CITY PLANNING COMMISSION

- APPLICATION:
1. Environmental Determination
 2. Plan Review for 26 apartment units on 1± acres in the R-3-R zone
 3. Lot Line Adjustment to merge two parcels (Subdivision Ord. Sec. 40.107)

APPLC. NO. P84-076

PARR APARTMENTS

SITE PLAN

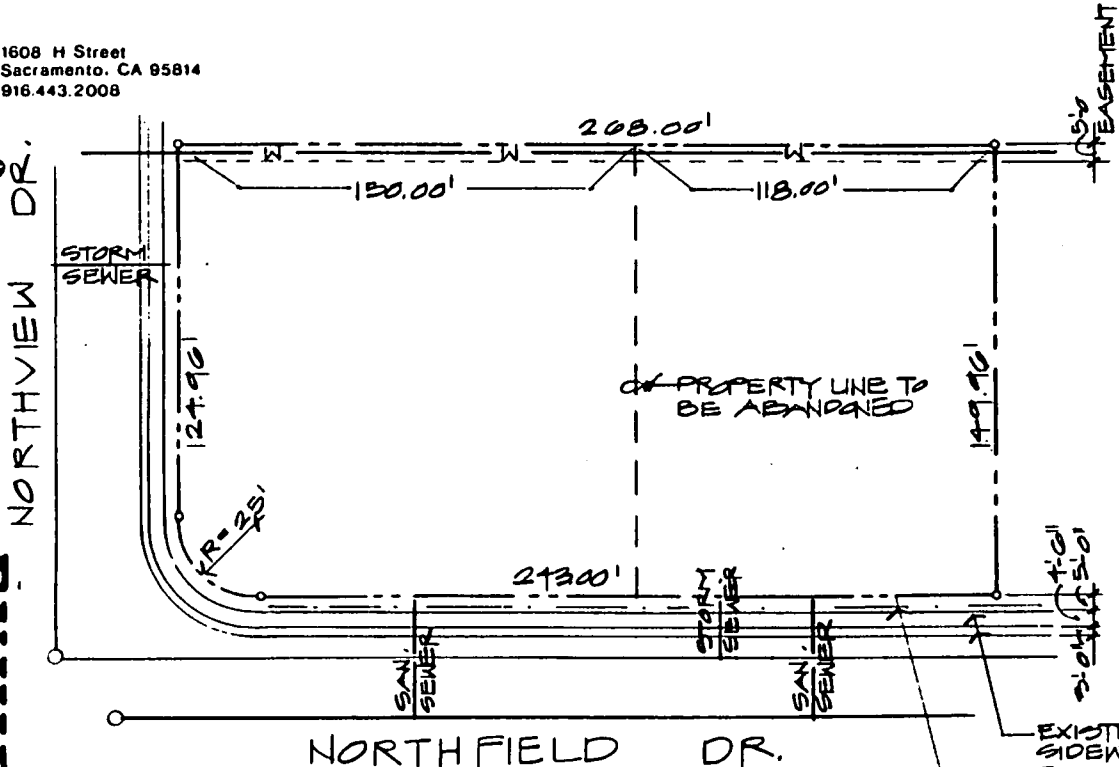
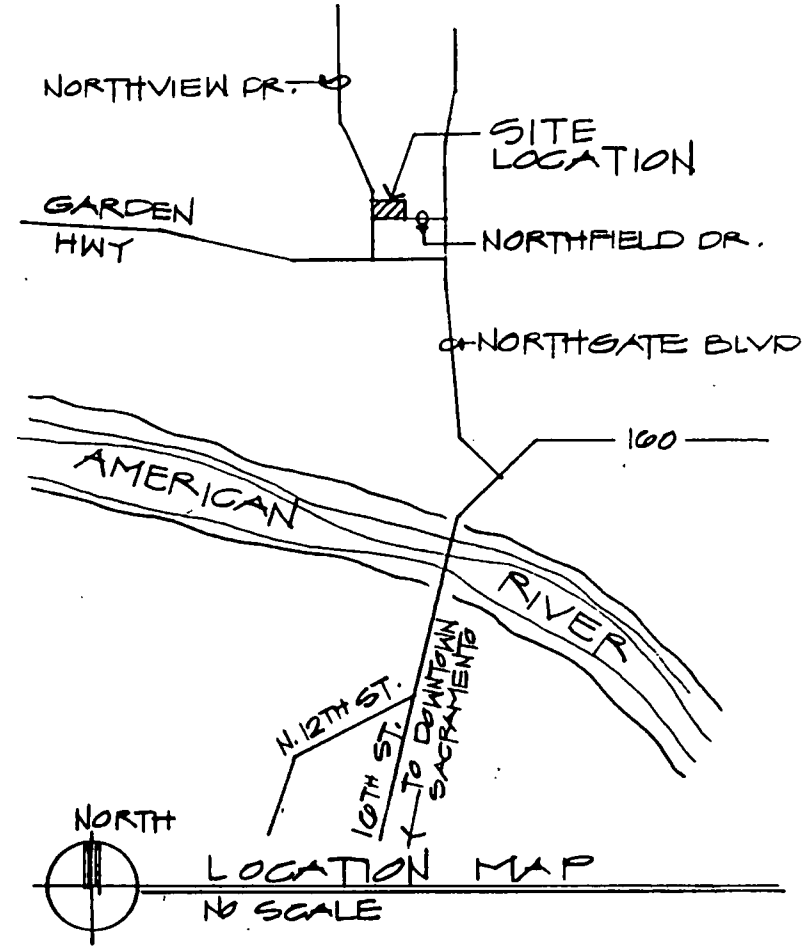
The staff, as well as the South Natomas Advisory Committee, had serious concerns regarding the design, configuration of the buildings and overall site layout.

- a. The south facing elevation of the building abutting Northfield Drive shall be redesigned to incorporate three stepped back sections with each offset set setback a minimum of two and one-half feet;

- b. The north building shall be moved back two and one-half feet to the north to the minimum five foot side yard setback to retain the interior courtyard space as approximately the same size as originally proposed;

- g. Pedestrian access from the court area to Northview Drive shall be eliminated. A three-foot high decorative open metal (wrought iron) type fence without gate shall be installed between structures to discourage tenant parking on street;

- 1) The south facing elevation of the building abutting Northfield Drive shall be redesigned to incorporate three stepped back sections with each offset setback a minimum of two and one-half feet;

- 2) The north building shall be moved back two and one-half feet to the north to the minimum five feet side yard setback to retain the interior courtyard space as approximately the same size as originally proposed;

- 7) Pedestrian access from the court area to Northview Drive shall be eliminated. A three-foot high decorative open metal (wrought iron) type fence without gate shall be installed between structures to discourage tenant parking on street.

EXHIBIT A

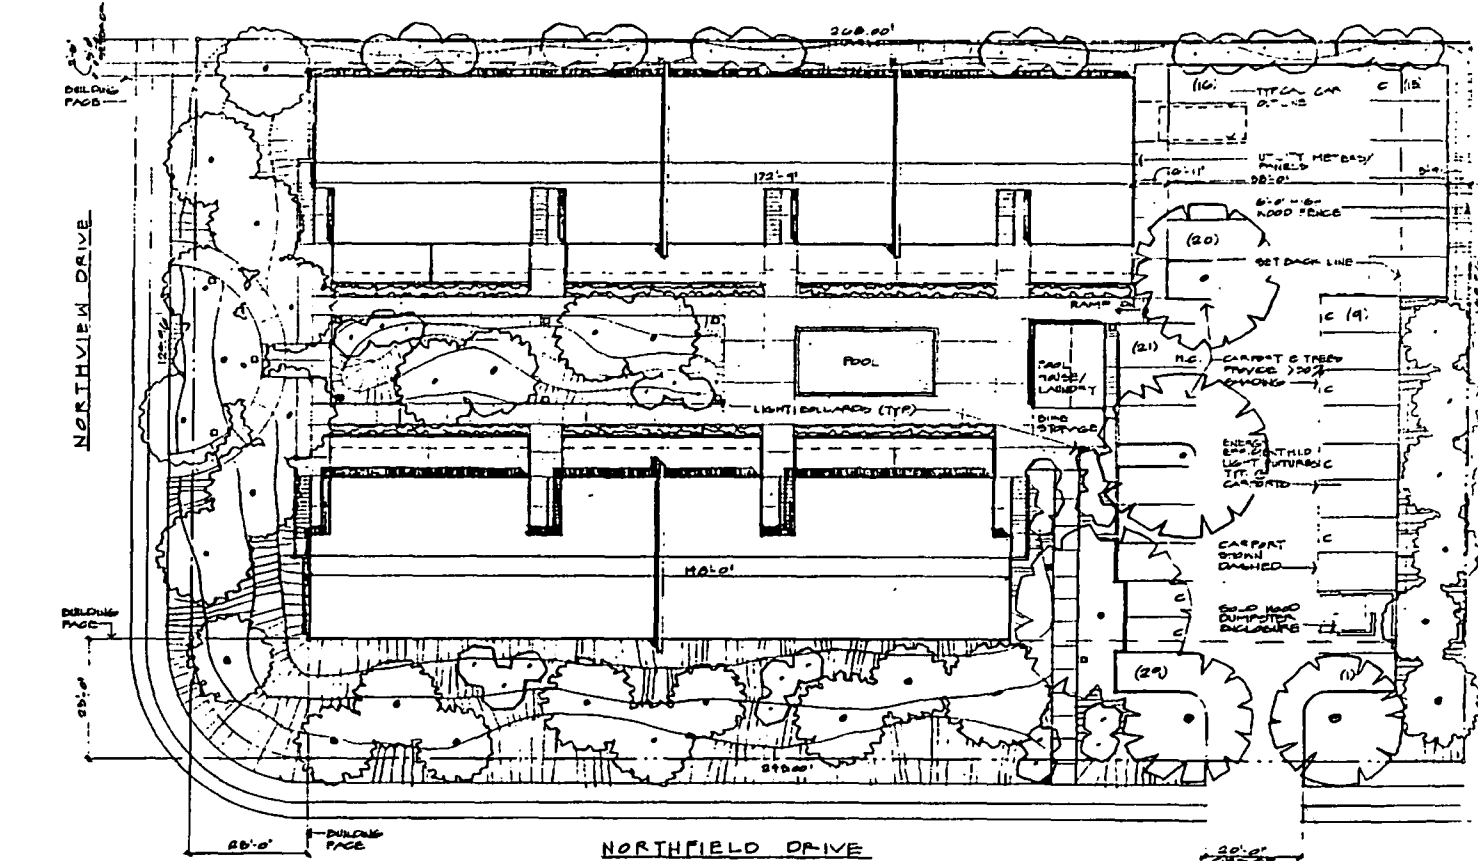
1. The original project (Exhibit A) consisted of two rectangular structures, two-stories in height constructed of T-111 plywood siding and composition shingle roof.

- c. The south elevation of the south building shall have alternating dipped and overhung eaves, fin walls and wood sun trellis;
- d. The north building shall have continuous 30-inch eave overhang at the north and south elevations;

- e. Horizontal hardboard siding shall be used in lieu of T-111 siding as originally proposed;
- f. Thirty percent of the on-site parking spaces shall be compact car spaces;

- 3) The south elevation of the south building shall have alternating dipped and overhung eaves, fin walls and wood sun trellis;
 - 4) The north building shall have continuous 30-inch eave overhang at the north and south elevations;

- 5) Horizontal hardboard siding shall be used in lieu of T-111 siding as originally proposed;
 - 6) Thirty percent of the on-site parking spaces shall be compact car spaces;
